Kimimage to City Centre Core Bus Corridor Scheme

NTA Observations on the Proposed Scheme Submissions

March 2024

Figure 2-5-4: Proposed Public Realm Improvements at Kimmage Village

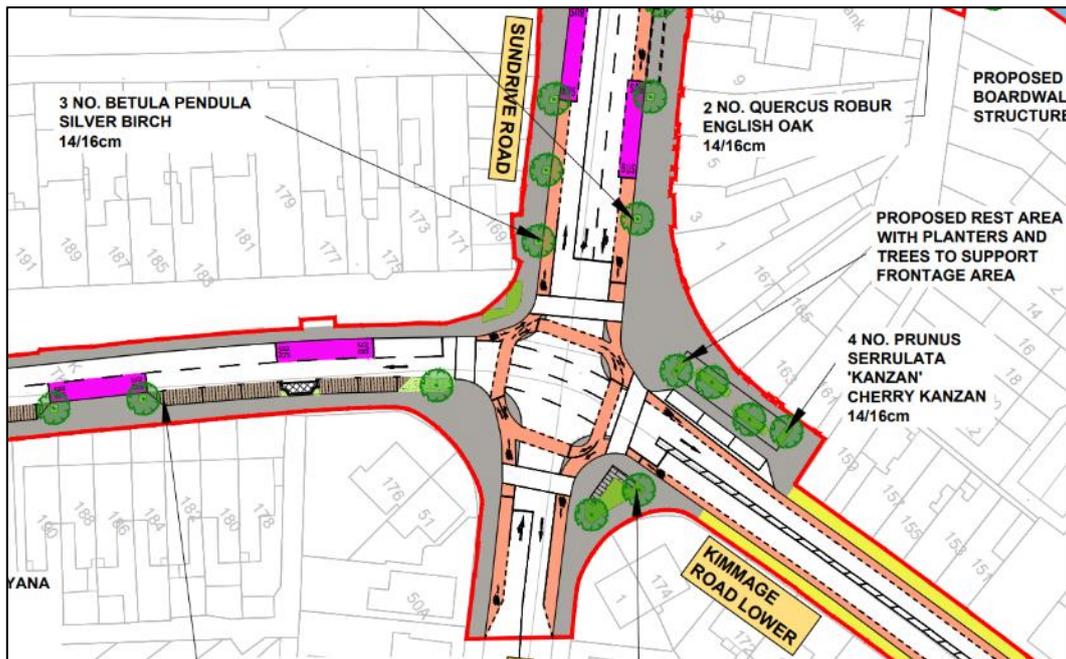
- 13) Support for public realm improvements / Comments on specific aspects of the proposals at Sundrive Cross. Curtailed public realm south of Sundrive Cross regretted by several submissions.

Generally the footpaths along the extents of the Proposed Scheme are not wide enough to accommodate much street furniture other than essential signs and lamp posts. Where there is more space such as at Kimmage Village, the Proposed Scheme will provide new street furniture to an appropriate degree. This is illustrated in Figure 2-5-4 (from EIAR Volume 3 Figures, Part 5, Sheet 3) which shows a proposed rest area with planters on the northwest corner of the junction at Sundrive

Road which is a sunny spot with a generously wide footpath area. The existing layout at this location was recently modified by Dublin City Council to extend the footpath with the removal of a small parking area. NTA understands that this parking is of particular use for customers of Thom's Pharmacy a short distance to the north, which is why it was shown to be retained in the Proposed Scheme.

Figure 2-7-1: Proposed Scheme Layout in Section 3, Sheet 08, with Alternative Option for Shorter Bus Lanes

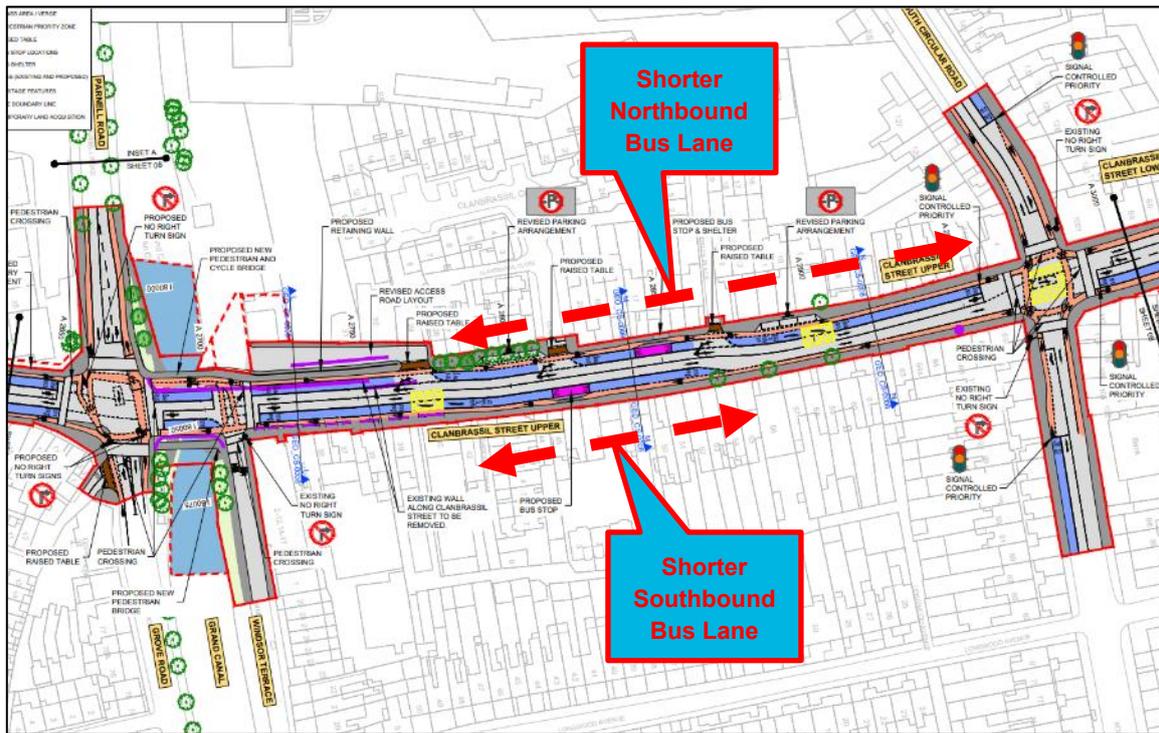
In conclusion, the alternative option of omitting the bus lanes at Robert Emmet Bridge and the northern approach ramp on Clanbrassil Street Upper so as to avoid the need for widening at the bridge, would undermine the key objective to maximise bus priority on this critical link of the core bus corridor which is congested at present with delays for buses.

Figure 2-9-5: Proposed Scheme Layout at Leonard’s Corner Junction

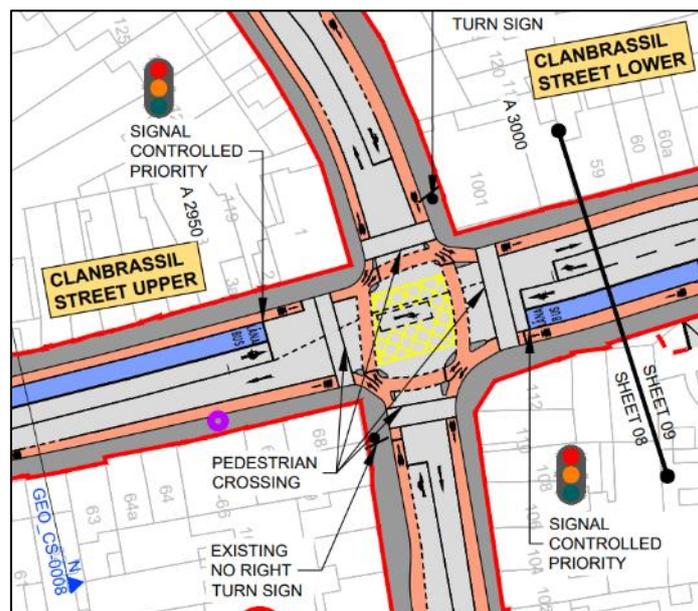
1. *“The provision of footpaths designed to the minimum width may not be sufficient in areas of high pedestrian traffic, particularly in urban villages and busy commercial streets, e.g. the footpath on Clanbrassil Street Lower (Sheet 09) and Harold’s Cross Road (Sheet 07).”*
2. *“The removal of the footpath on Harold’s Cross Road at the northern side of the park (Sheet 06) is generally not supported. If it is not possible to retain the footpath, it is suggested that the design of the junction of Harold’s Cross Road and Kimmage Road Lower could be reviewed to provide a new pedestrian crossing running north-south on Kimmage Road Lower and into a proposed new entrance into the park.”*
3. *“Footpath widths also need to account for congregations of passengers waiting in the vicinity of bus stops.”*

The Proposed Scheme consists mainly of modifications to the traffic layout along existing streets and roads. The existing footpaths are largely unaffected in the scheme proposals, and it was a key consideration not to reduce the existing footpath widths unless absolutely necessary. The existing footpath widths within the proposed scheme are generally more than satisfactory for the pedestrian traffic, which varies considerably along the various streets and roads. In the busiest parts of the route in Kimmage Village at the junction of Kimmage Rad Lower with Sundrive Road, and at the Leonard’s Corner junction of Clanbrassil Street with South Circular Road (as shown in Figure 2-9-5), the footpaths are generally about 3m wide, and wider in some places.

Figure 2-9-7: Snapshot from General Arrangement Drawing Sheet No.6

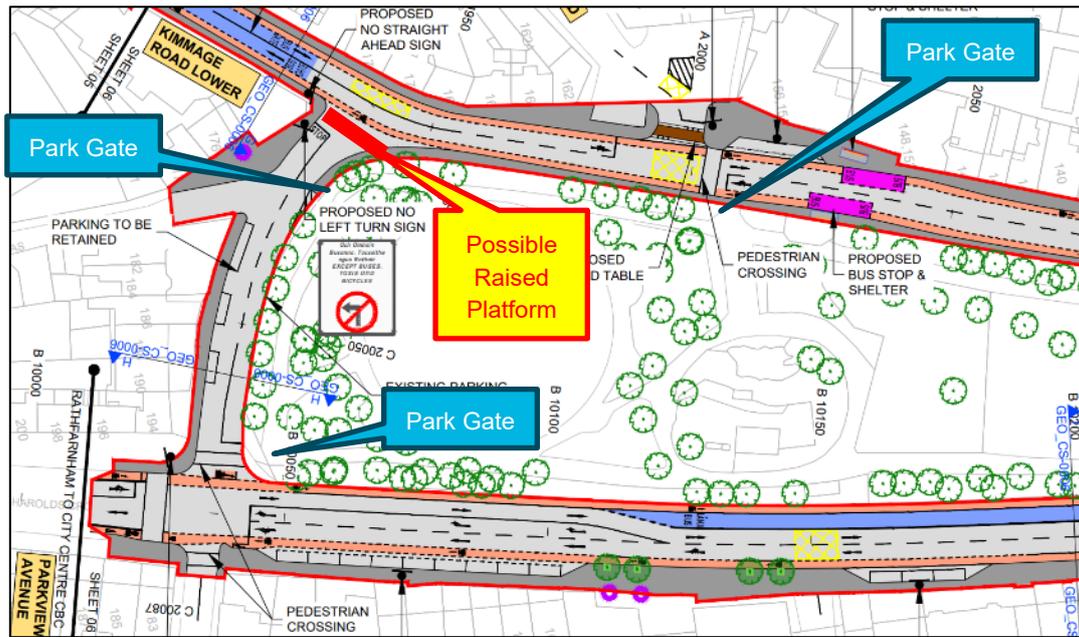
Point No.2 in respect of footpaths appears to refer to the short link street at the southern end of Harold's Cross Park (not the northern end of the park) between Kimmage Road Lower and Harold's Cross Road as shown in Figure 2-9-7. In the Proposed Scheme this short link street will be widened on the northern side to accommodate two-way traffic properly, alongside the retention of existing on-street parking for the houses on the southern side. The widening will require removal of the existing footpath along the northern side of the road adjacent to the park. The alternative option of removing the existing parking on the southern side of the street would adversely affect the amenity of the residents of the period houses, most of which do not have driveways for off-street parking, in a context where there is a general severe lack of alternative parking available in the area.

This section of street carries a very small flow of traffic at present, but that will increase slightly due to the proposed bus gate on Kimmage Road Lower at the northern end of the park, which will divert local access traffic around the southern end of the park towards Mount Jerome Cemetery, Mount Argus Road and homes opposite the western side of the park. There are three existing gates into the park as shown on Figure 2-9-7, including one at the southwestern corner. NTA accepts the suggestion by DCC Architect's Division that an improved pedestrian crossing could be provided at the junction at the western end of the link street where it joins Kimmage Road Lower, and this is indicated as a red line for a raised platform which would operate as a "courtesy crossing" as described in the *Design Manual for Urban Roads and Streets (DMURS)*.

Figure 2-10-1: Junction of Kimmage Road Lower and Ravensdale Park

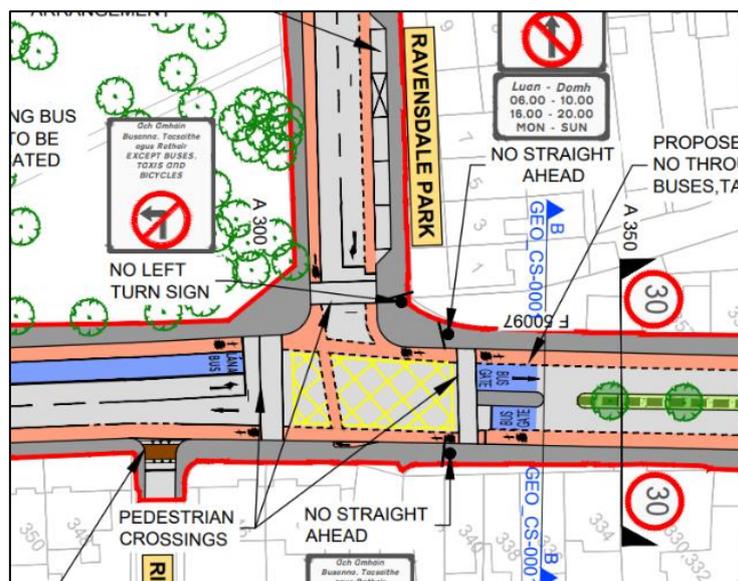
The submission states that the provisions for cyclists at three particular junctions do not fully comply with the Cycle Design Manual with insufficient segregation for cyclists at Ravensdale, Mount Argus View and Harold’s Cross Road / Kimmage Road Lower. The Proposed Scheme design at these three junctions is shown in Figures 2-10-1, 2-10-2 and 2-10-3, followed by a discussion about the provisions for cyclists.

Figure 3-1: General Arrangements Drawing Sheet No.6 at Harold's Cross Park South

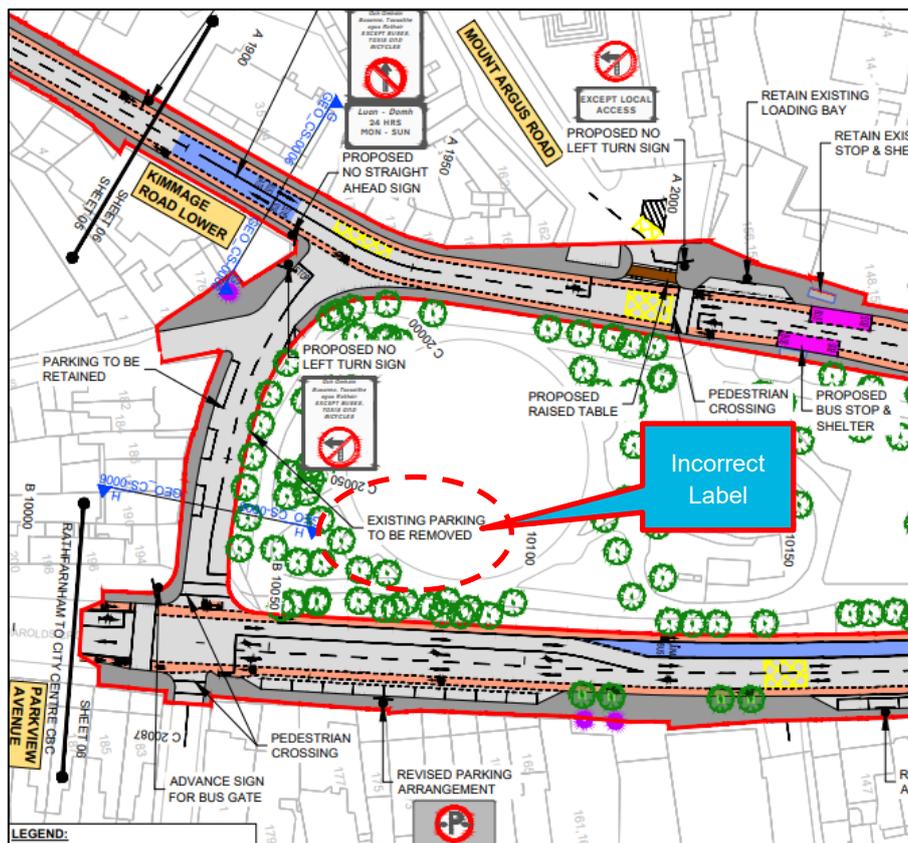
For Issue No.3 this submission says that there is an incorrect label on General Arrangement Drawing Sheet No.6 which points to "Existing parking to be removed" on the northern side of the short link street at the southern end of Harold's Cross Park. That label should say "Existing footpath to be removed". This error is corrected in this response.
